CITY OF TEMPE DEVELOPMENT REVIEW COMMISSION

Meeting Date: 10/25/2016 Agenda Item: 3

<u>ACTION</u>: Request for a Zoning Map Amendment from R-3 to R-4 Multi-family and a Development Plan Review for one new 18 unit apartment building within an existing 69 unit community for **GRANADA LAKES APARTMENTS**, located at 5701 S Rural Road. The applicant is Arizona Investment & Management.

PRELIMINARY LANDSCAPE PLAN 1" = 30"- 0"

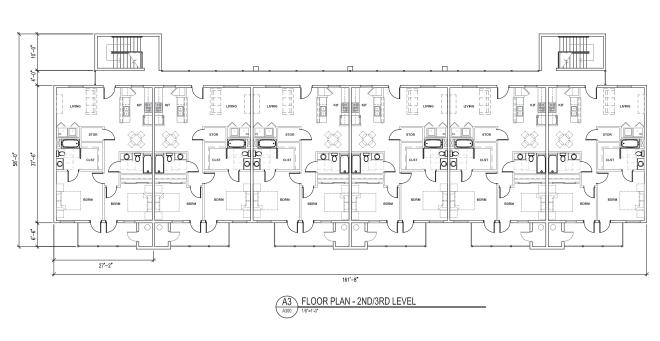
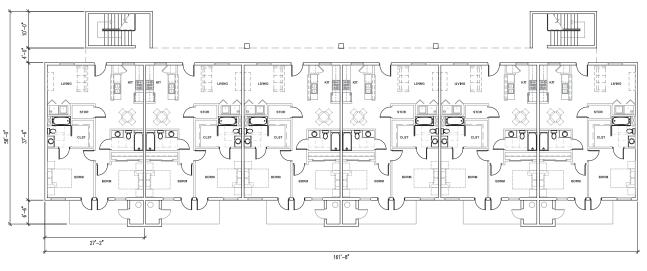
- 16. The plant palette is approved as proposed and specified on the landscape plan (10/03/16).
 - a. The area east of building three and west of the new building, which is currently parking, shall be landscaped with a combination of shade trees, turf and shrubs to provide a minimum mature vegetative coverage of 60% (exclusive of tree canopy) in lieu of the proposed decomposed granite. Modifications to meet this requirement shall be submitted to planning staff prior to submittal of construction documents.

A300

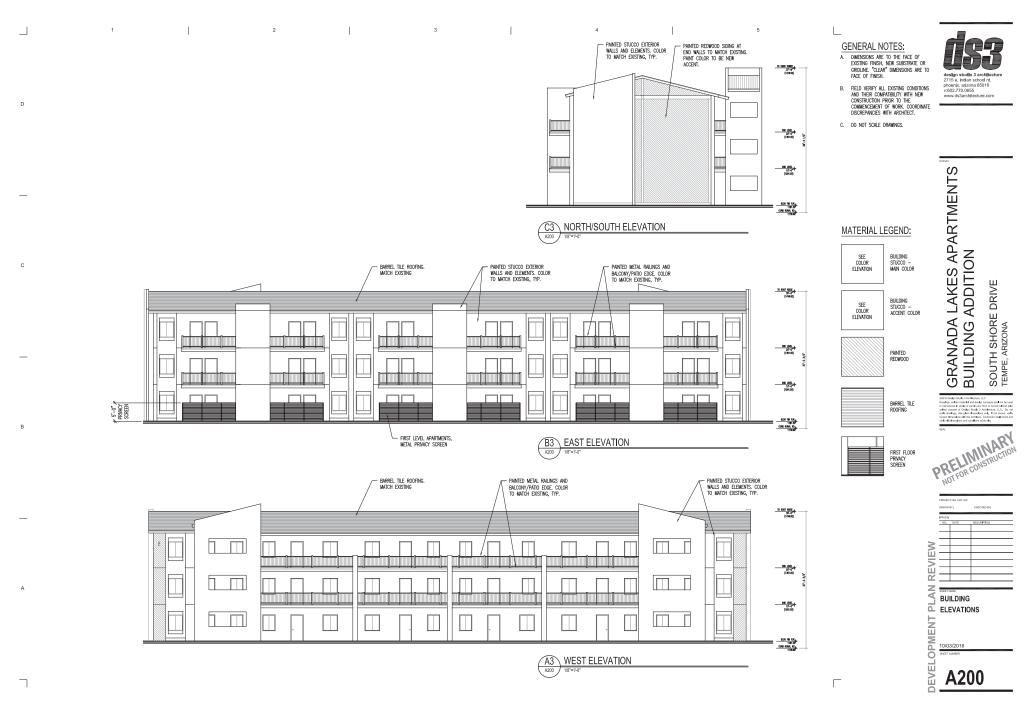
Prevention staff, openings into the enclosed stairwells was requested to increase visibility and decrease ambush opportunity in the stairwells. The applicant modified the elevations for the new building, and provided photo simulations of the existing buildings with proposed new paint accents between the window pop-outs to tie the old buildings to the new with more color variation. All

- 9. Exit Security:
 - a. Provide visual surveillance from stair towers into adjacent circulation spaces.
 - b. In instances where an elevator or stair exit is within 21'-0" of an alcove, corner or other potential hiding place, position a refracting mirror to allow someone in the exit doorway to observe in the mirror the area around the corner or within the alcove that is adjacent to the doorway.
